APPENDIX H

AIRPORT ISSUES

Re: Eagle Butte West LBA Tract

Eagle Butte Mine
Airport – Scoping Meeting Comment/Response Document
February 9, 2006

1 – EAGLE BUTTE LBA RELATIONSHIP WITH AIRPORT

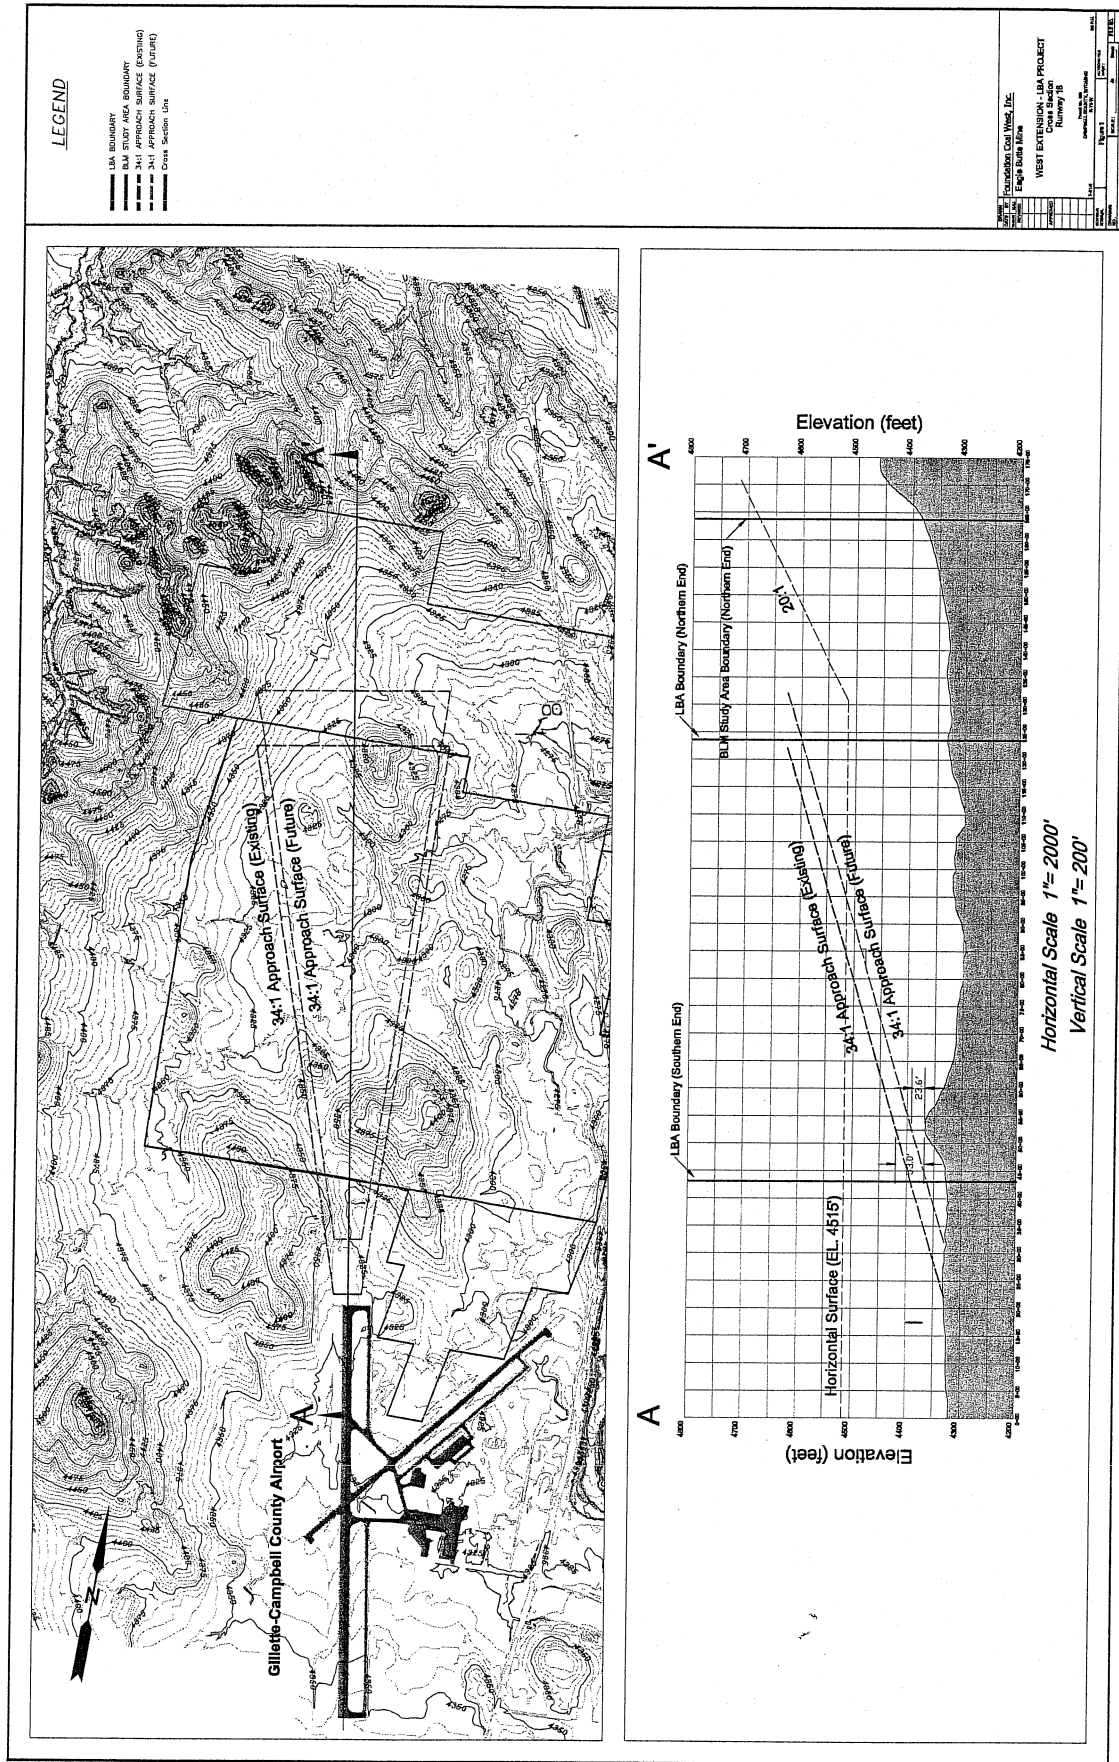
Comment: The closer mining operations are allowed to the airport environment the greater the chance that mining equipment will encroach the airport's protected airspace per Federal Aviation Regulation (FAR) Part 77. This regulation requires an airport's transitional area (Airspace) be protected by a 7:1 slope at least up to a limit that provides a 50-foot terrain and obstacle clearance. Mining equipment such as cranes, drilling masts, and haul trucks may penetrate this airspace. This is just one of several airspace issues that would need to be addressed. Aircraft need to be assured of this protected airspace while landing and departing. Because Campbell County has no height restriction zoning ordinances in place for the airport, the airport may be forced to closed if found to not be in compliance with FAR Part 77.

Response: An analysis (see attached documentation and schematic) shows that there is a small topographic rise (hill) at the southern end of the LBA boundary just north of Runway Three-Four (34). This is the only area within the Airport's approach surface where mining equipment could penetrate the Airport's 34:1 approach surface. The mines blasting drills operating at existing topographic elevations with masts extended would penetrate the approach surface by approximately 28 feet. Shovels and trucks would operate at bench elevations below the existing topography and therefore would be well below the approach surface.

The duration of time that the drill would be required to operate in the area where the approach surface is penetrated is considered short-term. A duration estimate was derived by calculating the volume of overburden obtained by lowering the 34:1 approach surface 81 feet to account for the drill height. This lowered surface was clipped against the existing topography to determine volumes of overburden that would require drilling. Whether using the existing approach surface or a future expansion approach surface (see Table 1) the maximum volume of overburden to be moved is approximately 4 million bank cubic yards. This equates to approximately two weeks to one month of drill time necessary to prepare the area for blasting and subsequent mining. The Airport agrees that similar protocols that were established for the cross-wind runway would be acceptable in this case.
